**APPROVED**  
**MINUTES OF THE MEETING**  
**20 September 2001**

**20 Sept 2001 Project: Pacific Northwest Aquarium**

Phase: Concept Design

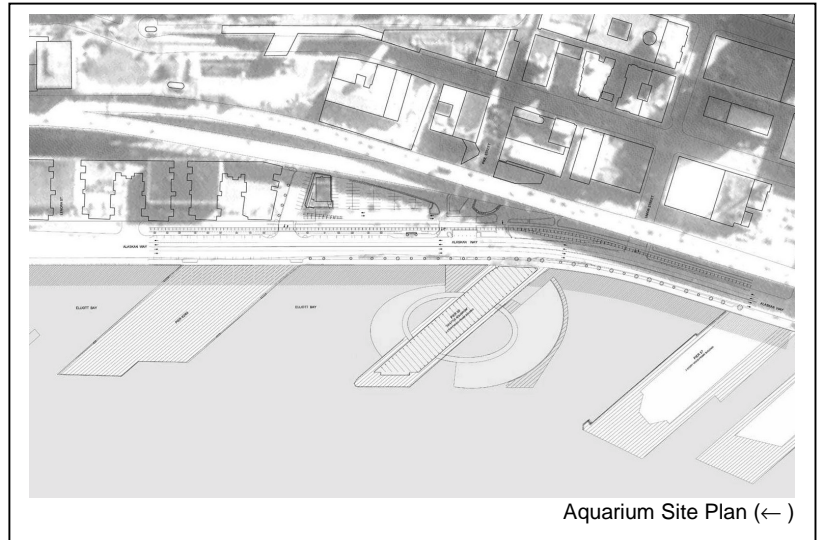
- urges the team to simplify the design and the juxtaposition of the spiral and ovals forms, and the historic shed, and believes that the geometric relationship between these structures should be further refined within the building and outside of the building to make it readily apparent to visitors, rather than just in plan;

- encourages the team to study the proportion of open spaces and urges the team to consider whether or not the sea stack within one of these spaces is an appropriate architectural addition;

- encourages the team to develop the design parti three-dimensionally from the water level to the roof;
- encourages the team to develop the design of the roof as a screen element with the functional needs in mind, protecting the exhibits from external wildlife, and simplify the roof shape, letting the exhibition itself become the main feature rather than having the roof overwhelm the structure;

- Recognizing that the roof forms in the section drawing are very activated, while the roof forms represented by the model are fairly flat, would like to know which representation is more accurate.

- Believes that the unifying theme of the circulation spiral is very graceful. Is concerned about the faceted nature of the roof, and would like to know how the roof screen will be linked with the spiral geometry.

- In the section drawing, would like the team to describe the vertical element.
  - Proponents stated that this would be a sea stack, located within a very large water space, to create a sculpted, focal element. This may an extension of the rock-scape and this could be a staging area for changing exhibits, or an opportunity for space for demonstration work. Further stated that this element could be very abstract, but could contain some functional elements.

- Believes that the spiral is very clear in plan, would like to know if the team has considered developing this spiral in section as well, perhaps as a ramp that rises from the first floor to the second floor, then continuing to the upper level.

- Believes that the spiral is central to the scheme, and this is easy to see in plan. Believes that people would not be able to perceive this spiral, and questions why the design team has developed the spiral design parti so strongly. Is not convinced that the spiral is the unifying geometry.

- Is concerned about the large area of open space and water in between the buildings, and does not believe that this scale is appropriate.
  - Proponents agreed that there may be a disconnect between the spiral and many other design decisions. Does not believe that the experience would be diminished by this design. Further stated that people would be able to move from one structure or exhibit to another, in a fluid or minimal way.

- Recognizes that the diagram shows a connection between the Aquarium and the city, but does not see a physical connection or relation between the spiral and the urban environment beyond. Would like to see a representation of this geometry beginning or ending. Would like visitors to perceive the

spiral and is concerned that the spiral ends inside, at the oval ramp. Believes that there should be another oval or ellipse expression that would mirror or counter the interior circulation geometry, against which the roof scapes could be developed.

- Would like to know for sure whether or not there would be nets attached to the roof and the roof structure. Recognizing that there may be exhibits that would attract birds, believes that nets would change the section diagram dramatically. Believes that this is a strong, functional exhibit question that needs to be addressed. Believes that the scheme would benefit from simplification and clarification.

- Is concerned that the sea stack sculpture will interfere with the open space between the buildings and is not consistent with the concept plan. Believes that the open space between the buildings should be left void.

- Proponents stated that the activated roof form represents the accurate design proposal. The roof is a form based on movement, with three-dimensionality, rather than a lid. The roof may or may not cover the entire exhibit on this level. This roof form would also act as an edge or foil that would wrap the corners and become the walls of this exhibition space. The opacity of the material would change as well. There may be some netting incorporated into the roof design, in order to retain some creatures.

- Proponents stated that the curvature of the plan is very strong, and the screen elements would have to be driven by the geometry of the plan. The pile structure below deck may be radial. This radial movement may be expressed in the design of the structure. The perception of the building from above would be further improved by the landscaped architectural edge around the perimeter. Further stated that this would be developed throughout the design process.

- Proponents agreed that the unifying spiral might work in section as well as in plan, and this would be addressed through further design development.

- Proponents stated that through the development of this design, the team did focus on the purity and the legibility of these geometries. Further stated the spiral, ending at the entry threshold, would provide an opportunity to clarify this geometry.

- Proponents stated that the sea stack is a request of the client. Further stated that it may become like an exhibit itself or it could be an out of water resting spot for real creatures.
